## Technical Memorandum

Subject: Icy Strait Point - Incidental Harassment Authorization Application Modification  
(File No. 18889)

From: Dan Gunderson, BergerABAM

To: Robert Pauline, NOAA Fisheries

**Figure B-3: Vibratory Pile Driving Monitoring Plan**

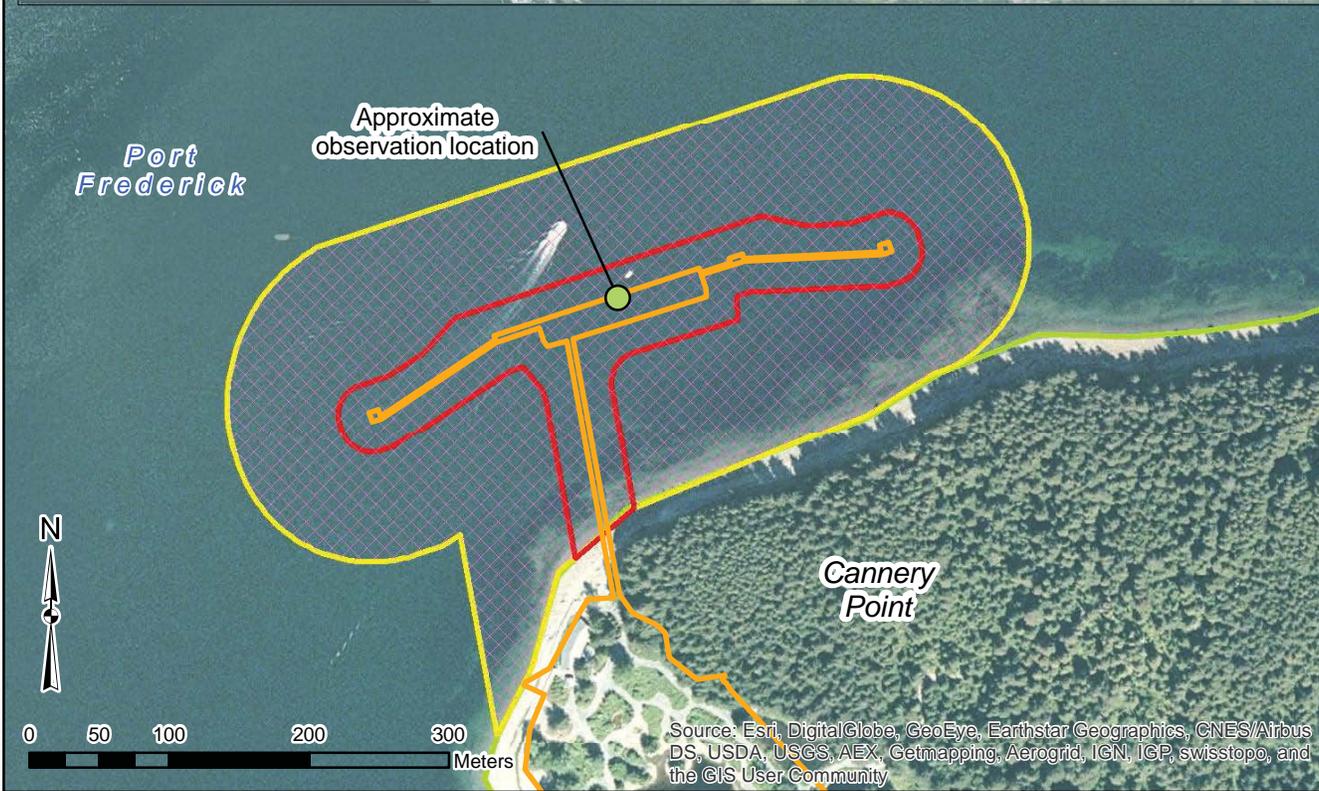
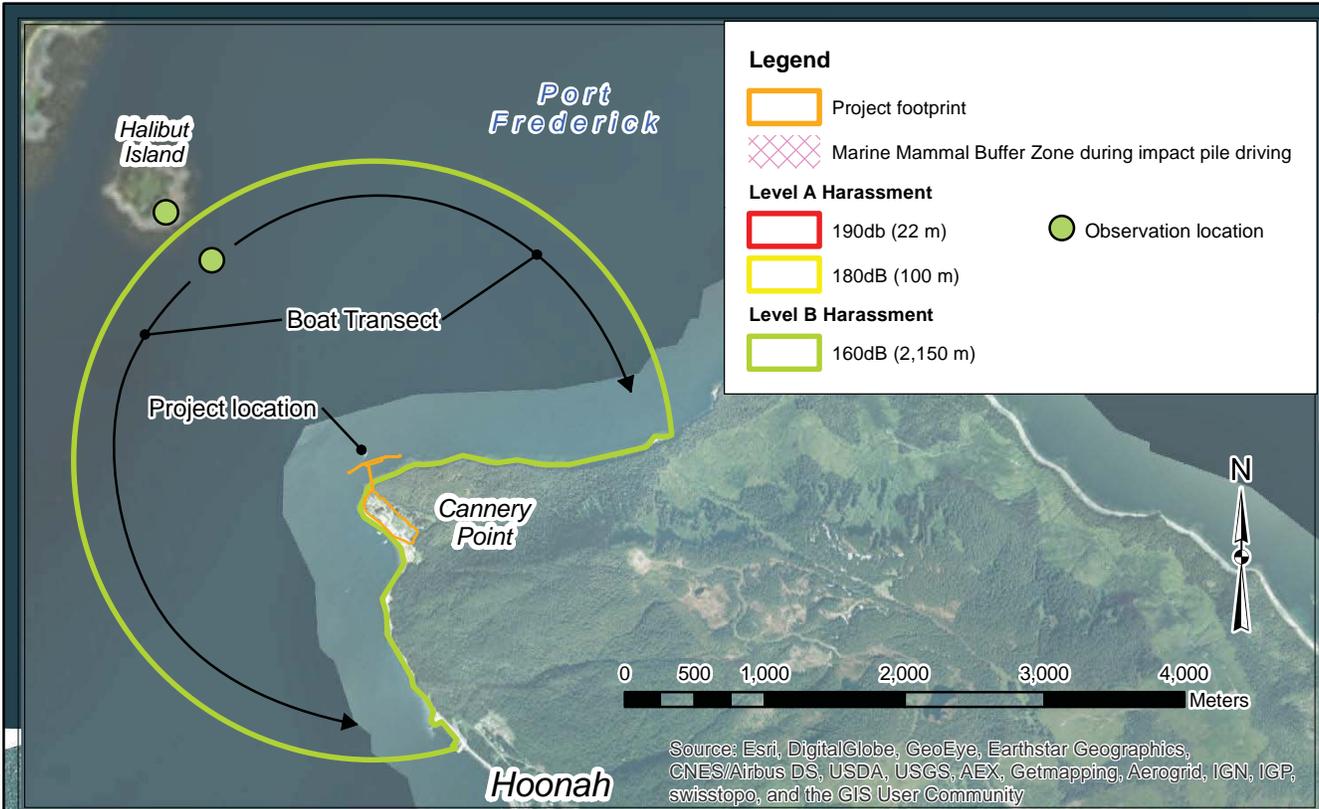
The area within the Level B harassment threshold for vibratory driving (see Figure 3) will be monitored by three qualified marine mammal observers. One field monitor will be stationed either on the pile driving rig or in the immediate vicinity; a second qualified field monitor will be stationed on or in the vicinity of Halibut Island across Port Frederick; and a third qualified observer will monitor from a boat that is conducting meander transects throughout the Level B harassment zone.

Marine mammal presence within this vibratory Level B harassment zone, if any, will be monitored, but vibratory pile driving activity will not be stopped if marine mammals are found to be present. Any marine mammal documented within the Level B harassment zone during vibratory driving would constitute a Level B take (harassment), and will be recorded and reported as such.

The vibratory pile driving monitoring plan is shown graphically on Figure 3.

**Appendix B - Marine Mammal Monitoring Plan**  
**Figure B-2: Impact Pile Driving Monitoring Plan**

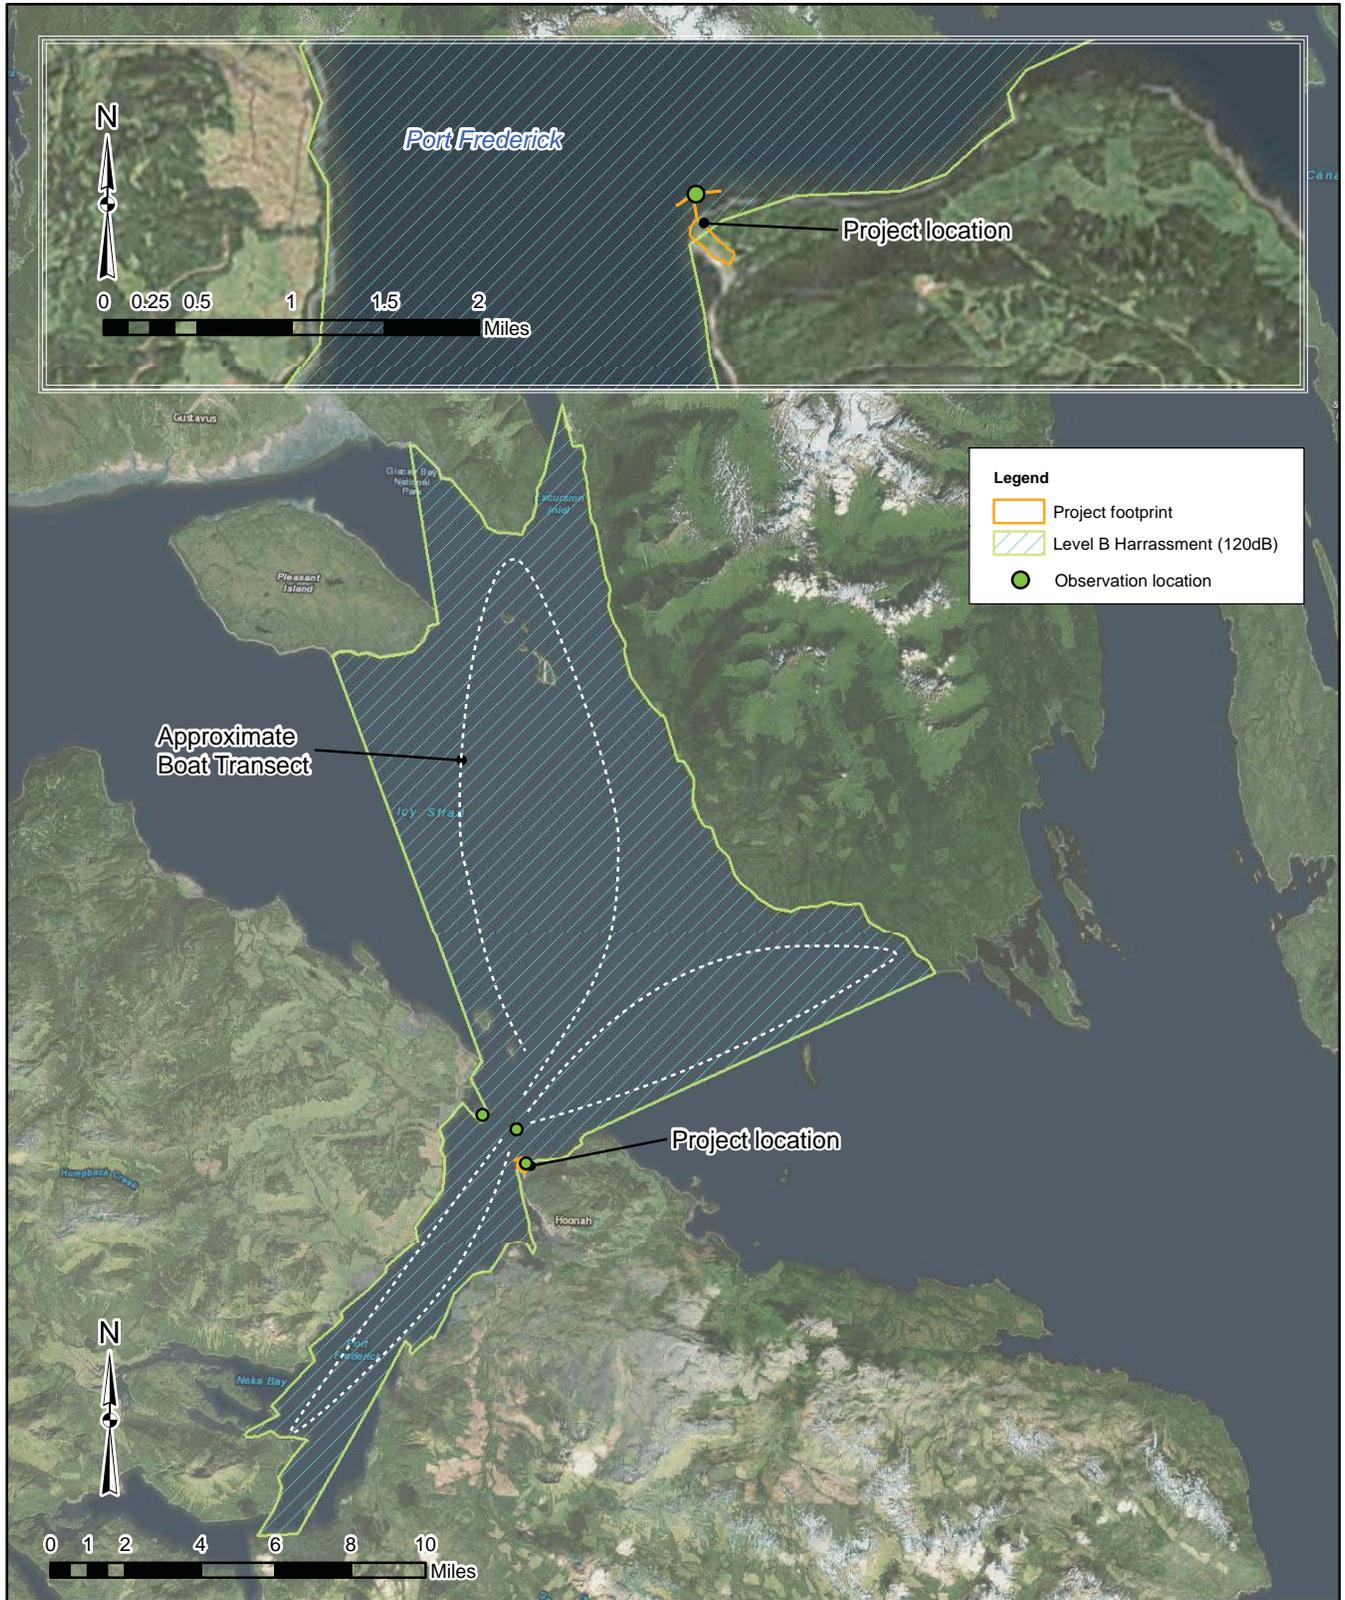
The area within the Level B harassment threshold for impact driving (see Figure 2) will be monitored by the field monitor stationed either on the pile driving rig or in the immediate vicinity, and by a second qualified field monitor stationed on or in the vicinity of Halibut Island near the 2,150 meter limit of the Level B harassment zone. A third qualified observer will monitor from a boat that is conducting a transect along the 2,150 meter limit of the Level B harassment zone. Marine mammal presence within this Level B harassment zone, if any, will be monitored, but impact pile driving activity will not be stopped if marine mammals are found to be present. Any marine mammal documented within the Level B harassment zone during impact driving would constitute a Level B take (harassment), and will be recorded and reported as such.

The impact pile driving monitoring plan is shown graphically on Figure 2.
